QorIQ LS1046A Reference Design Board

Errata

This document lists and describes all known errata for the LS1046ARDB. It also provides available workaround with detailed explanation, wherever required, for each erratum.

Figure 1. E-00001 workaround

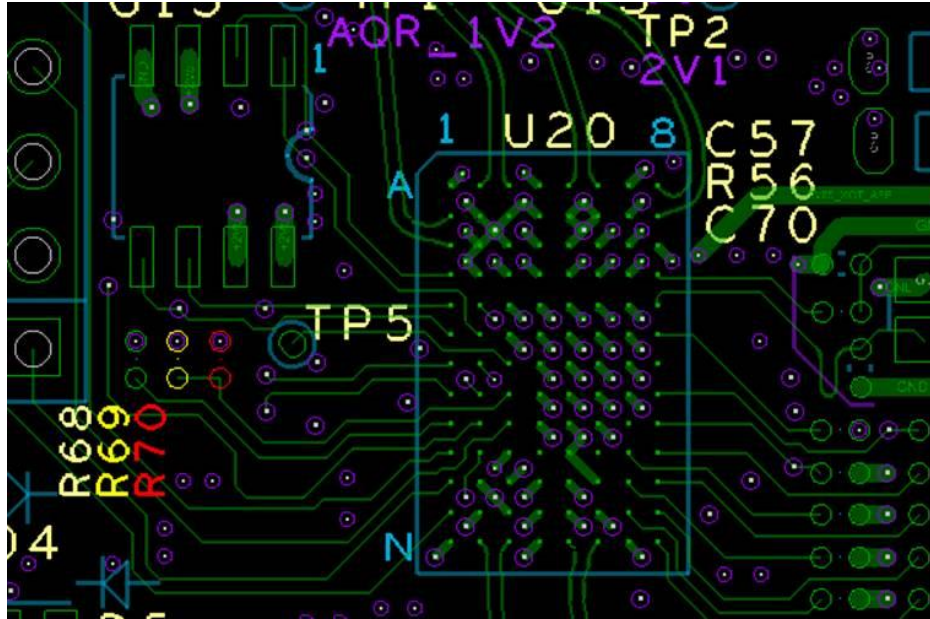
E-00001: AQR107-ES2 MDIO voltage configuration changed as per ES2 part requirements

Description: As per AQR107-ES2 revision A0, the polarity of MDIO_1P2_SELECT_N is inverted as follows:

- When pulled low, the voltage level is 1.8 V - 2.1 V
- When pulled high, the voltage level is 2.5 V - 3.3 V

Impact: AQR107 firmware cannot be programmed and MDIO cannot work.

Workaround: Remove R70 (0 Ω) and populate R69 (4.99 K Ω).

Fix plan: The above mentioned rework has been implemented on all revision B boards. Starting board revision B1, no rework is needed.

Figure 4. E-00003 workaround

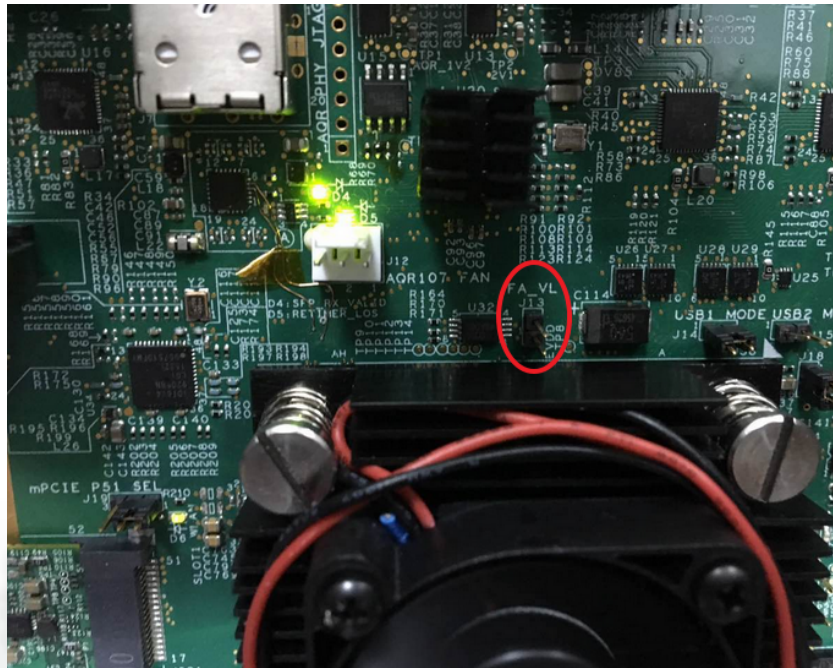
E-00003: FA_VL pin is connected to VDD

Description: The FA_VL pin has a jumper (J13) to select GND or VDD. On some early-shipped boards, J13 is shorted. The J13 shunt needs to be removed to select GND.

Impact: This may impact Linux kernel stability.

Workaround: Remove the J13 shunt.

Fix plan: The J13 shunt must be removed from all boards with revision B or later.
